TECHNICAL SPECIFICATION CHANGES

STEAM GENERATOR LEVEL REACTOR TRIP MODIFICATION

SIGNIFICANT HAZARDS EVALUATION
CALLAWAY STEAM GENERATOR
LOW-LOW LEVEL REACTOR TRIP MODIFICATION

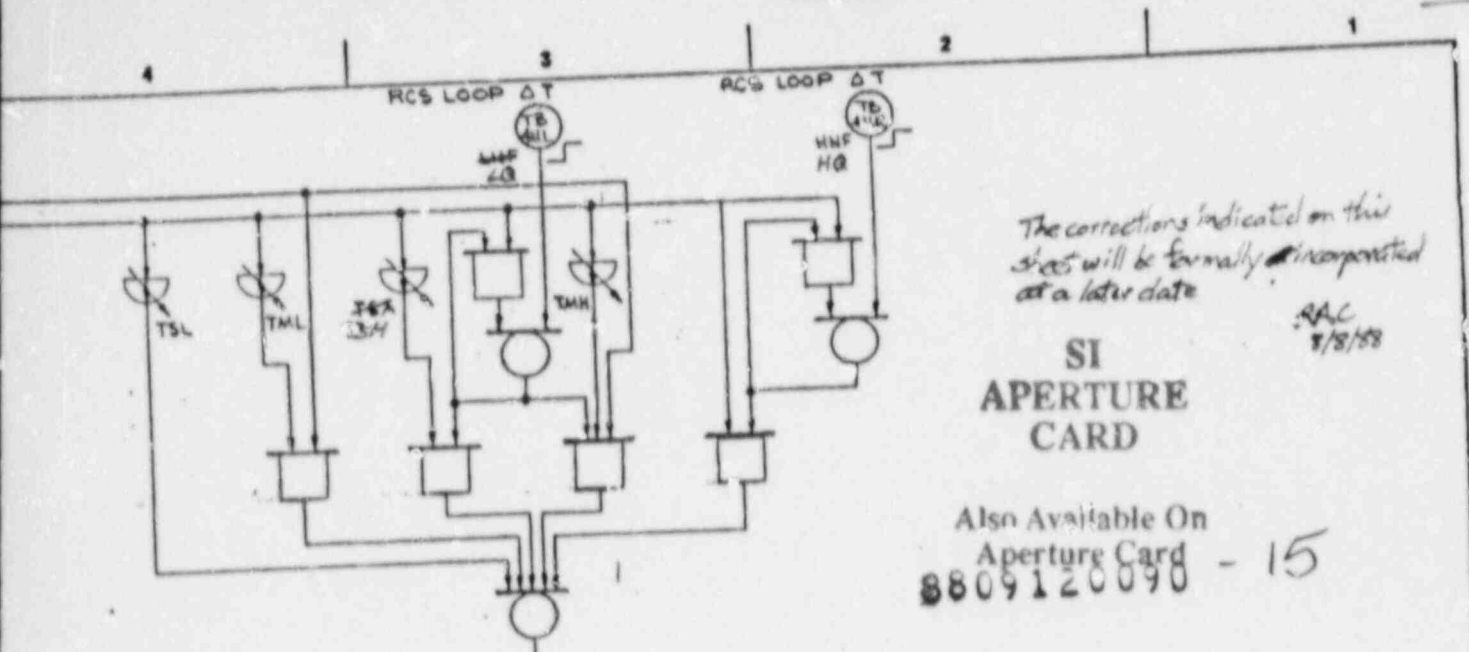
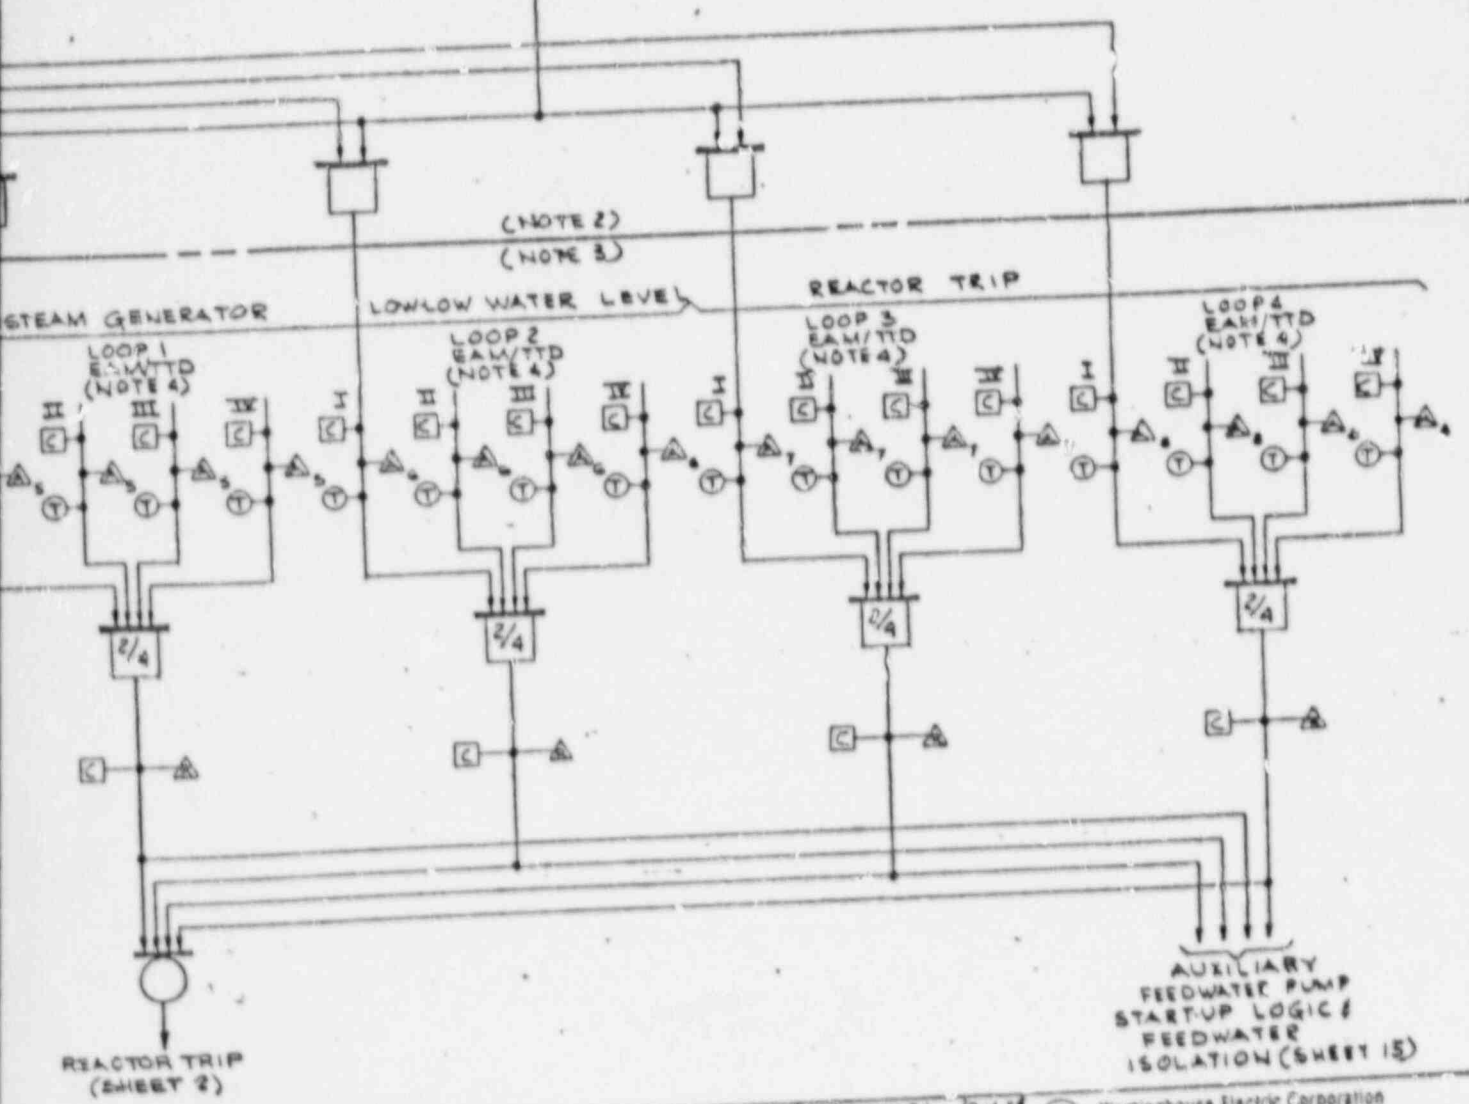
The corrections indicated on this sheet will be formally incorporated at a later date

FIGURE 7.2-1
FUNCTIONAL DIAGRAMS
(STEAM GENERATOR
TRIP SIGNALS,
Continued on
SHEET 7A)

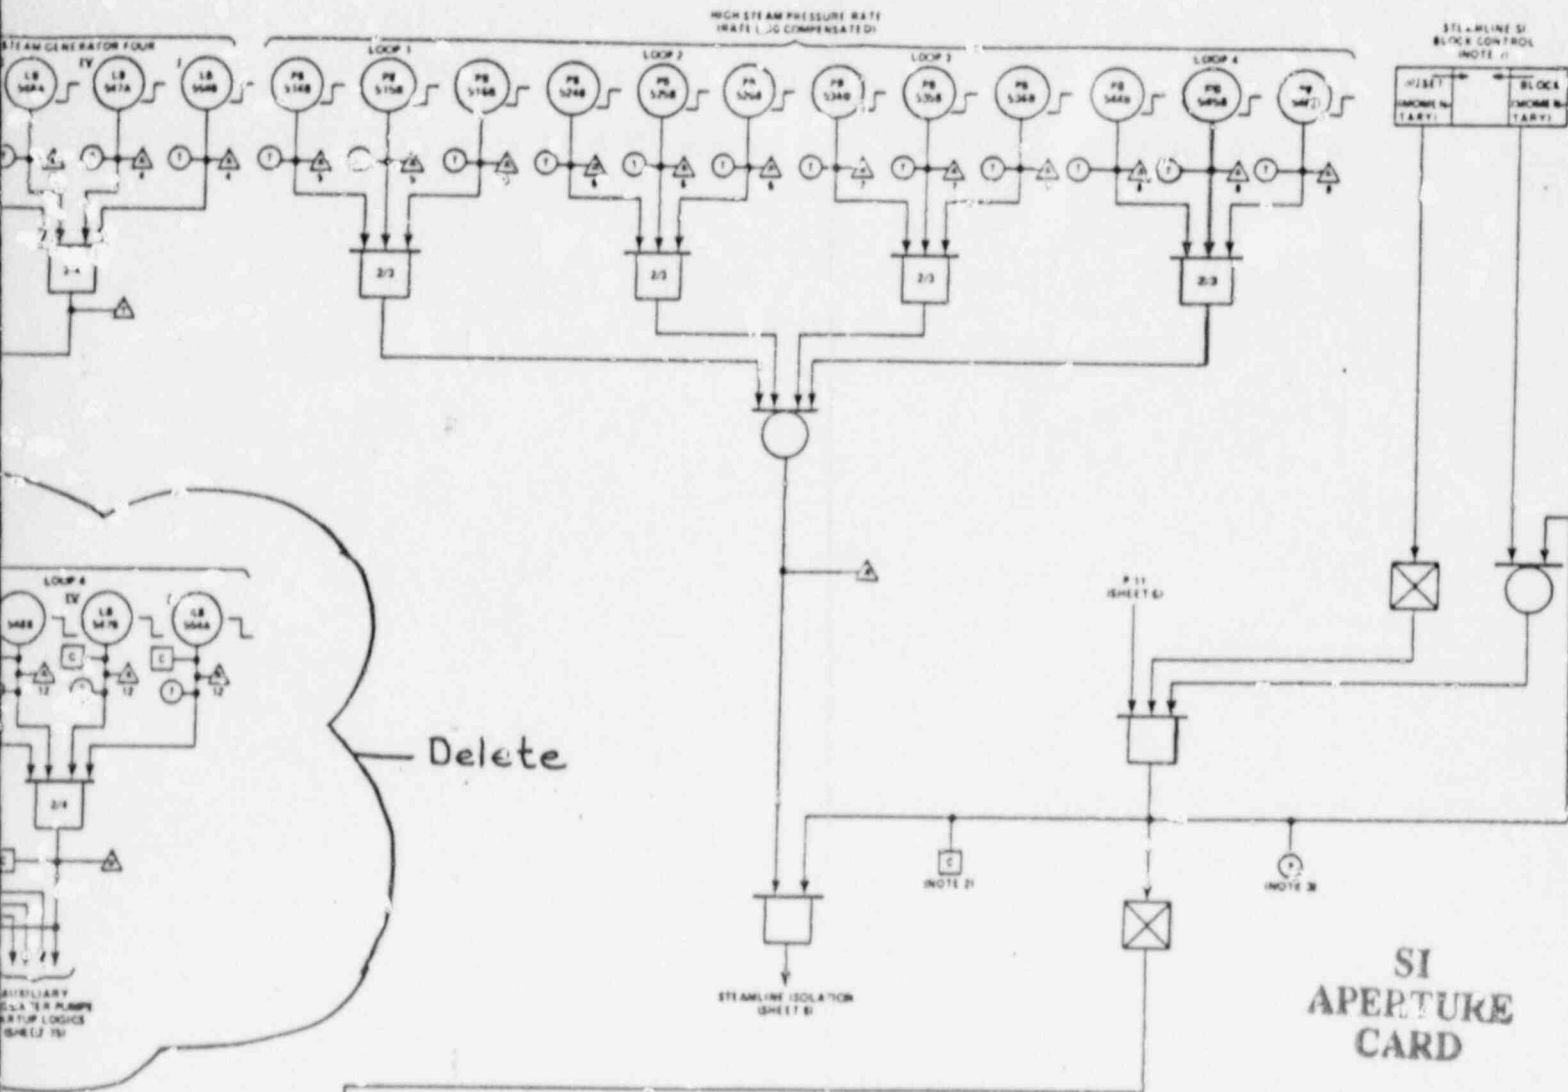
Delete

Add

CALLAWAY PLANT
FIGURE 7.2-1
FUNCTIONAL DIAGRAMS
(STEAM GENERATOR
TRIP SIGNALS
CONTINUED FROM SHEET 7 (SHEET 21))

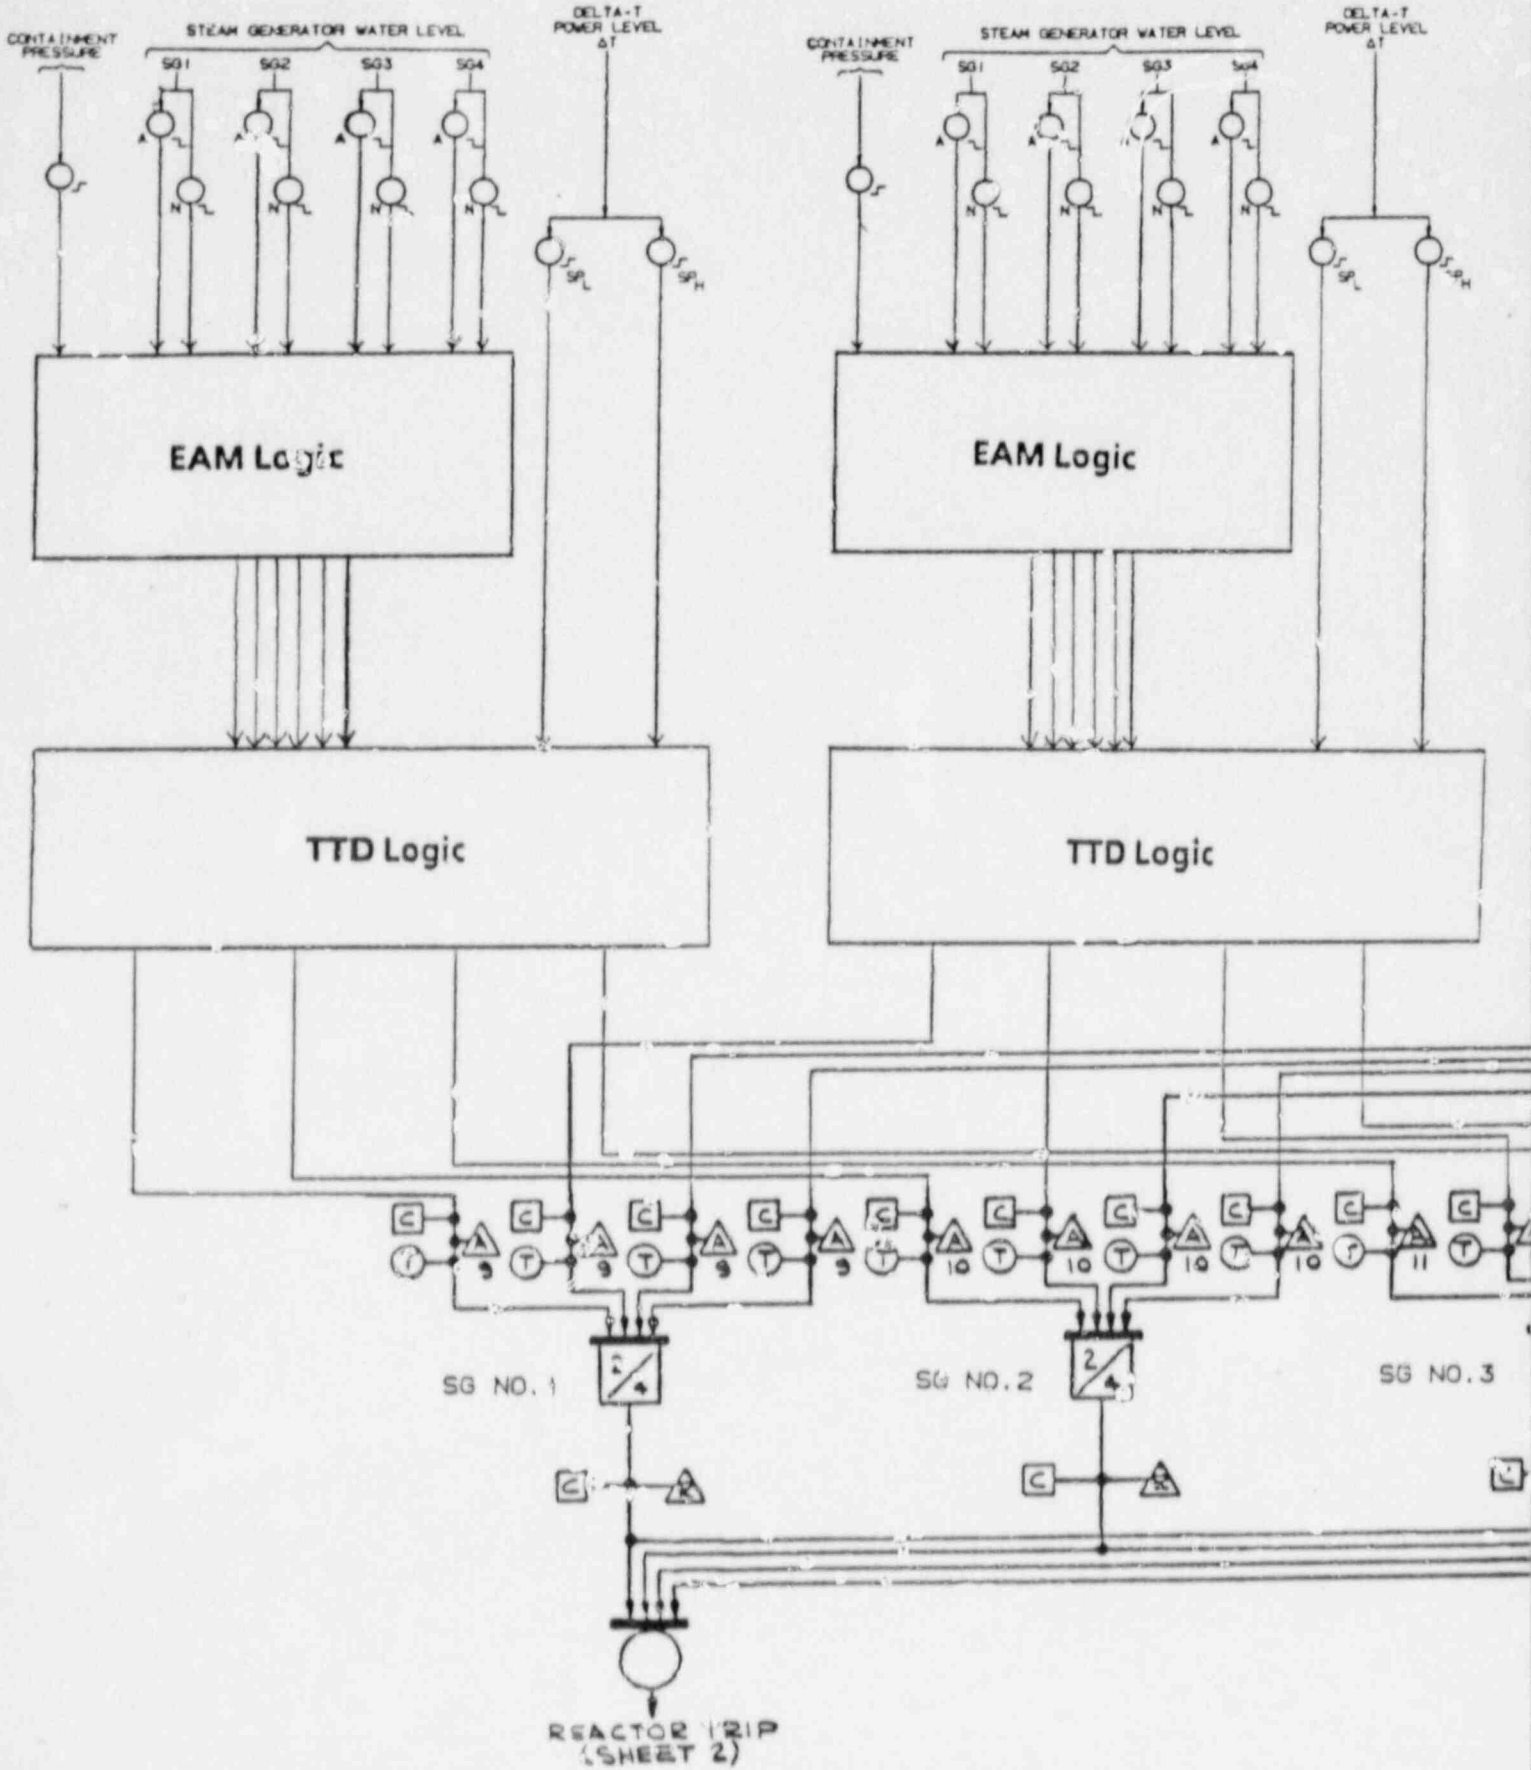
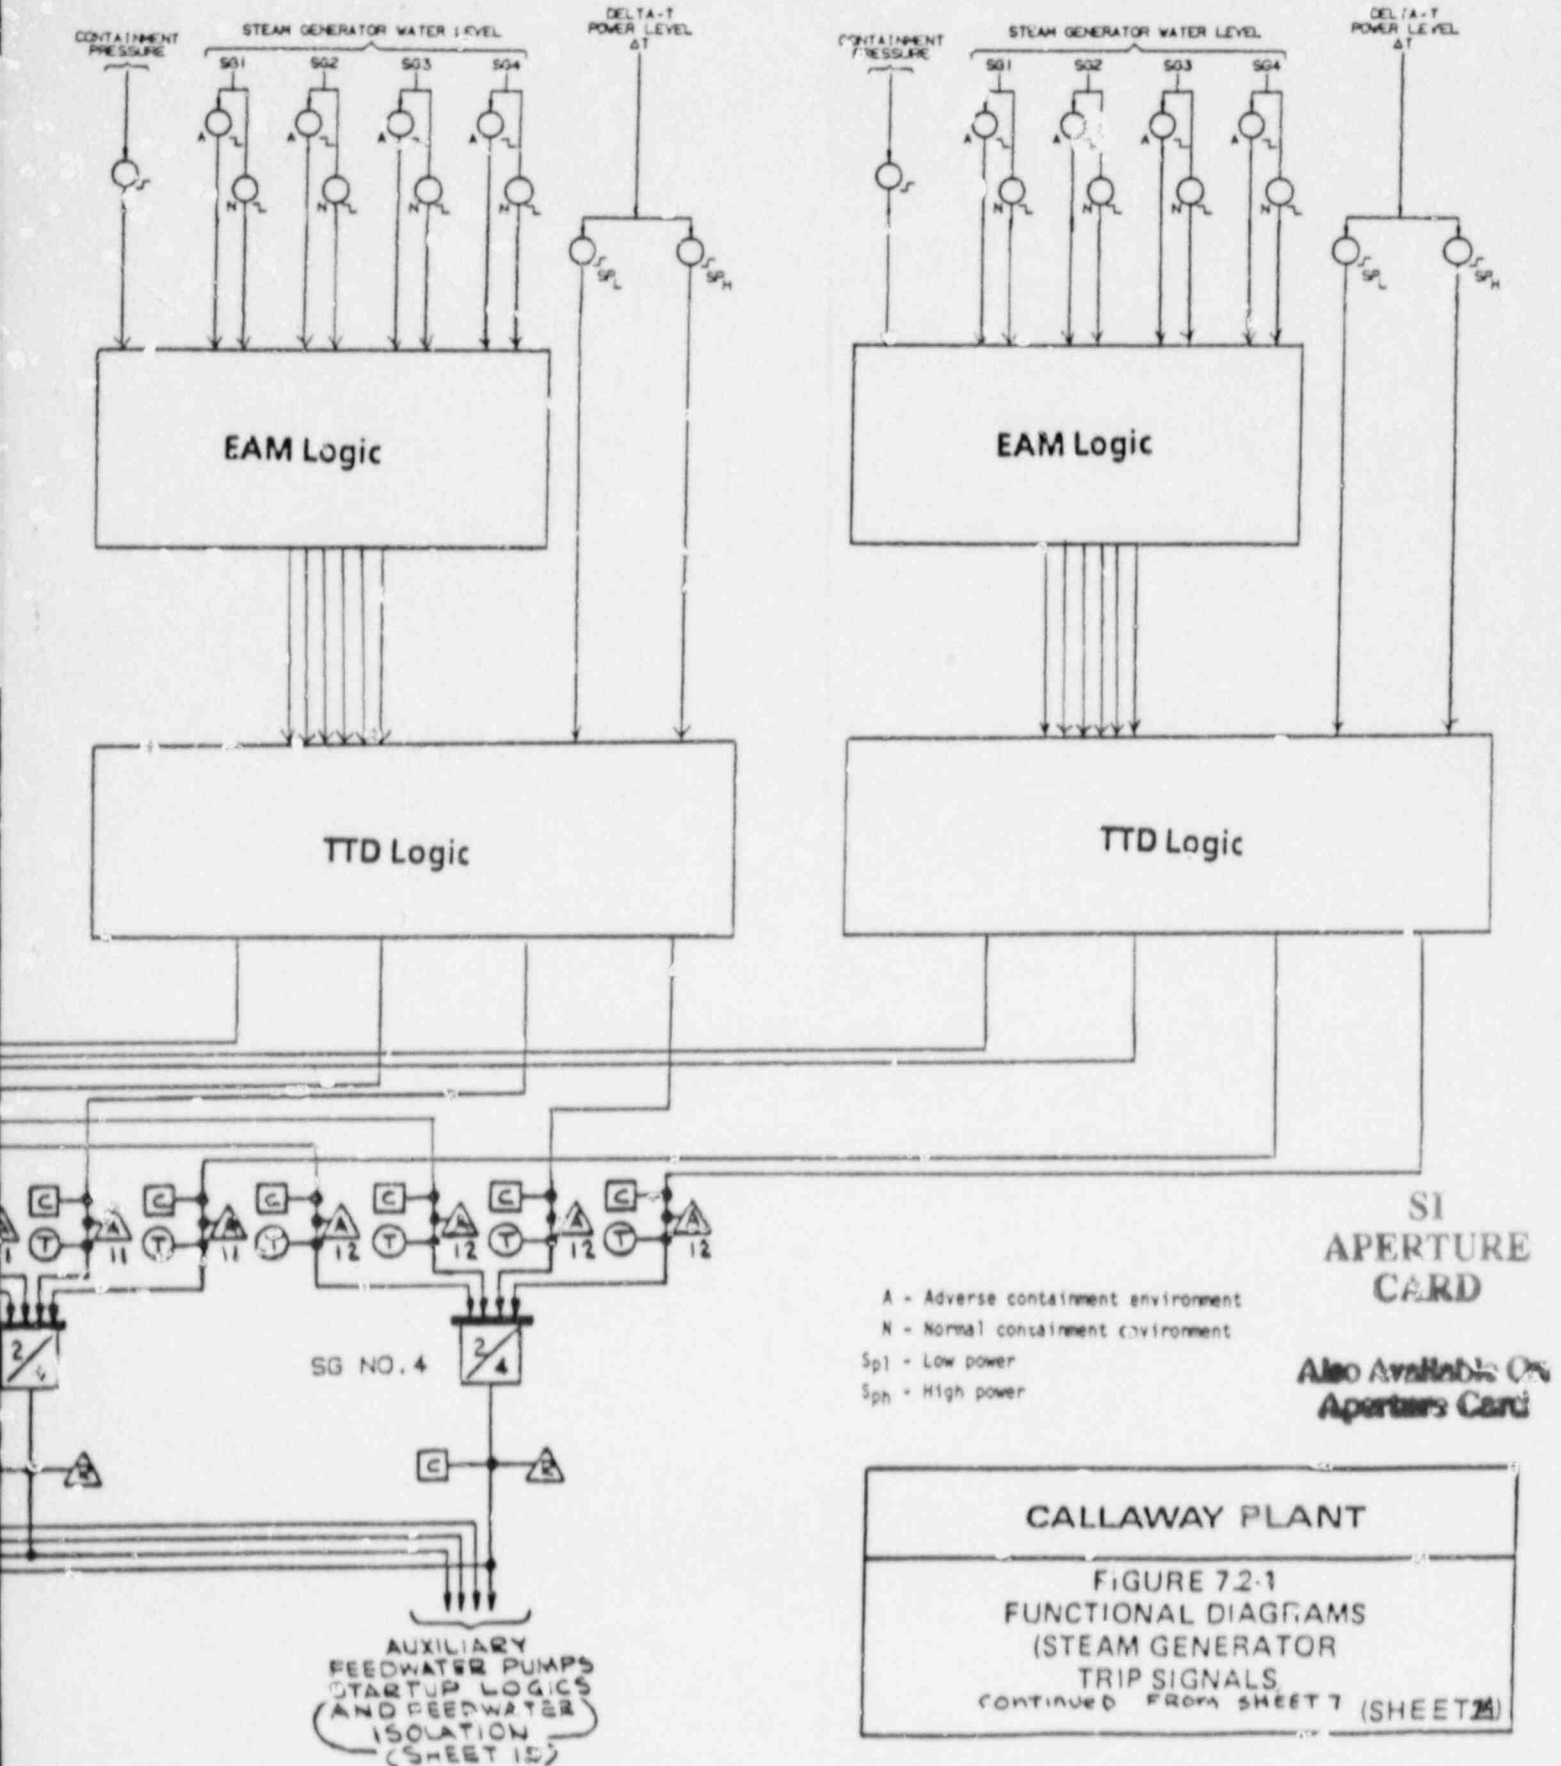
1. THE ENVIRONMENTAL ALLOWANCE MODIFIER/TRIP TIME DELAY LOGIC ON THIS SHEET IS APPLICABLE TO CALLAWAY UNIT 1 ONLY. SEE SHEET 7 FOR THE STEAM GENERATOR LOW-LOW WATER LEVEL REACTOR TRIP LOGIC APPLICABLE TO WOLF CREEK UNIT 1.
